# Coastal Access – Marsland Mouth to Newquay lengths MNQ1, MNQ3 to MNQ5 and MNQ7 to MNQ11

## Representations with Natural England's comments

July 2020

**Document A:** MCA/MNQ8/R/1/MNQ0973 & MCA/MNQ8/R/3/MNQ1031 – Map showing the normal proposed route of the ECP across the beach, the suggested optional alternative routes and the locations of establishment works. Map submitted by Natural England.

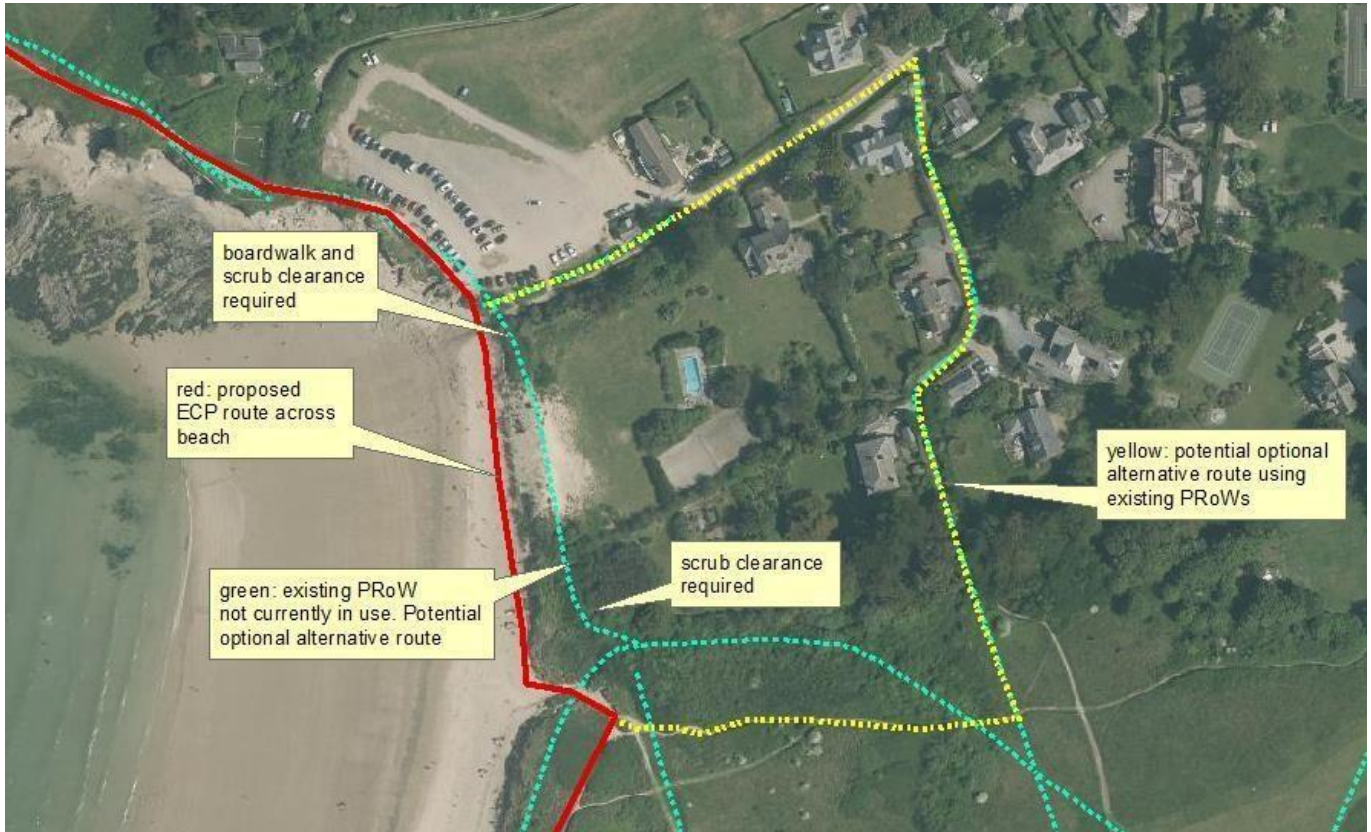
<b>Representation number:</b>	MCA MNQ8/R/1/MNQ0973
<b>Organisation/ person making representation:</b>	Cornwall Countryside Access Forum
<b>Route section(s) specific to this representation:</b>	Map MNQ8a; route sections MNQ-8-S029 to MNQ-8-S031 inclusive
<b>Other reports within stretch to which this representation also relates:</b>	N/A
<b>Representation in full</b>	
<p>There are proposals for a new boardwalk and footbridge at Daymer Bay, and these are welcomed and supported.</p> <p>However, the route crosses the beach for part of this length, and high tides are now meaning that this route often becomes unusable at such times. An off-beach alternative is needed to overcome this tidal problem, but has not been addressed by the proposals here.</p>	
<b>Natural England's comments</b>	
<p>During our initial discussions with the Access Authority (AA), Cornwall Countryside Access Forum and the South West Coast Path Association, the issue of the current beach route becoming impassable at exceptional high tides was not raised. Therefore our England Coast Path (ECP) proposals in report MNQ8 do not propose an alternative off-beach route for such occasions.</p> <p>Following their recent site visit, the AA have now confirmed that at high spring tides during stormy conditions the whole beach can become inundated with water which makes walking the proposed route difficult during the hour either side of high tide. There is a fence at the back of the beach which prevents the walker from accessing the higher ground and circumnavigating the beach. Therefore, whilst the AA agree that the normal route of the ECP should still cross the beach as proposed in our report, we have recently worked with them to investigate two options for walkers during periods when the 'ordinary' route is unavailable because of the tides.</p> <p>One option investigated was the public footpath, not currently in use, along the top of the sand dunes at the back of the beach (see document A, section 5 below). This hasn't been a walked route for at least 20 years. However, following recent storms in February 2020, the dunes have become severely eroded back from the fence line and so the definitive line of this footpath is no longer usable as it would now traverse the unstable and slumped face of the dunes (see document B).</p> <p>The second, and our proposed, option is for walkers to follow the existing network of inland public footpaths and permissive routes (see document A) which avoid the beach. We consider this route to be a suitable informal route for coast path walkers on the rare occasions when the beach route is impassable. The AA have recently improved signage at either end of the route affected by the tides to inform users of the options.</p> <p>Due to the infrequency of the high spring tides and the presence of an existing and signed route on the ground, we do not propose to recommend an optional alternative route for the ECP.</p>

The first and currently preferred option is a public footpath, not currently in use, which runs along the top of the raised bank at the back of the beach (see document A, section 5 below). The Access Authority have confirmed they intend to reinstate the use of this footpath, which would then provide a suitable optional alternative route for walkers during states of high tide. They will shortly commence discussions with the landowner about this. Depending on timescales, Natural England may be able to fund any necessary establishment works for this route, initially estimated at £7,000, through the coastal access programme.

**Document A:** MCA/MNQ9/R/7/MNQ0975 – Map accompanying the full representation from the Ramblers' Association, Cornwall. Showing the definitive map record of the public footpath, St Merryn 2.

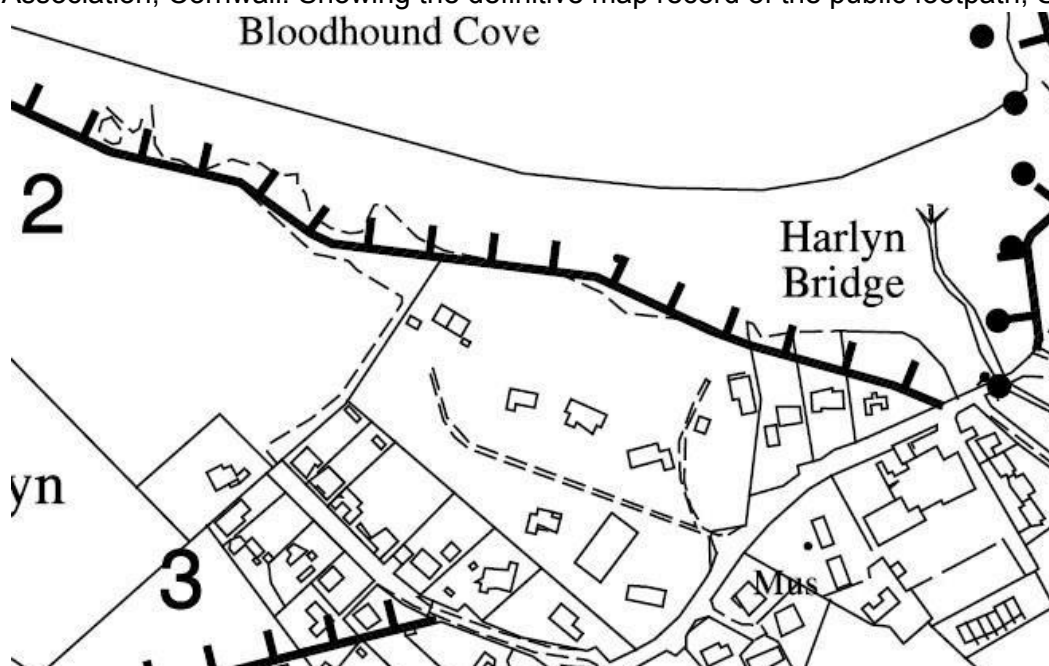
Porthcothan: We strongly support routing the path across the Towans as proposed in the Report, rather than along the road, for the reasons given in the report. The new route does require a crossing of the stream and there is no proposal to provide a bridge or stepping stones. We suggest that consideration should be given to providing a means of crossing, suitable for average winter water levels. The road bridge remains an alternative for exceptional water flows.

We welcome the positive engagement from the Ramblers' Association during the development of our proposals and the supportive comment in its representation.  
New signs will be erected to inform walkers that the road route is available for users during occasions when the stream becomes difficult to cross. Section 10.2.22 of report MNQ10 outlines the proposed costs for the additional signage to be installed at this location.

**Document A: MCA/MNQ10/R/4/MNQ1031** – Photos of views of the proposed route across Treyarnon Bay at high tide following heavy winter rain. These accompanied the ‘other’ representation from the South West Coast Path Association.

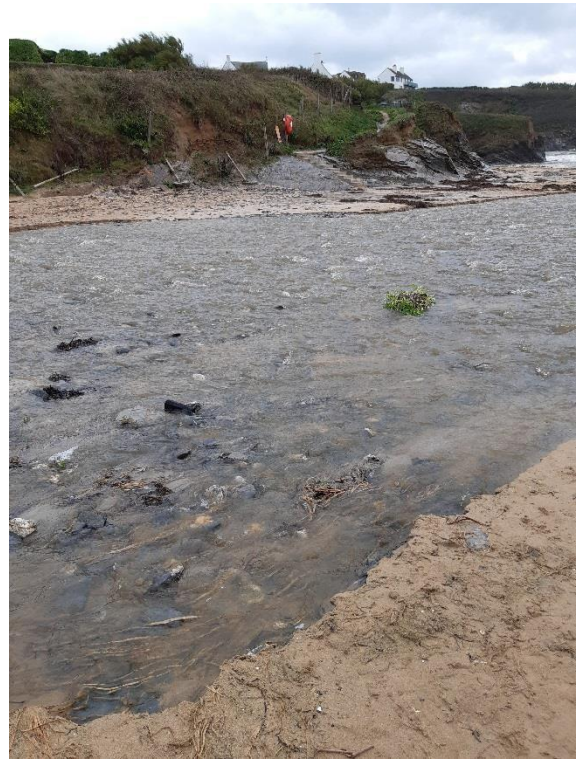
<b>Report map reference:</b>	MNQ10b
<b>Route sections on or adjacent to the land:</b>	MNQ-10-S050
<b>Other reports within stretch to which this representation also relates</b>	N/A
<b>Summary of representation:</b> Porthcothan: The 'tunnel' of vegetation surrounding the steps leading from the beach, through which the new route will pass, has great aesthetic and nature value, and should therefore be kept.	
<b>Natural England's comment:</b> The majority of the vegetation will be retained, with just some light trimming to increase the head height within the 'tunnel'.	
<b>Relevant appended documents (see Section 5):</b> <b>Document C:</b> Relevant to MCA/MNQ10/R/6/MNQ0907 and MCA/MNQ10/R/7/MNQ0907 – Photo of the 'tunnel of vegetation' referred to in the representations. Document submitted by Natural England.
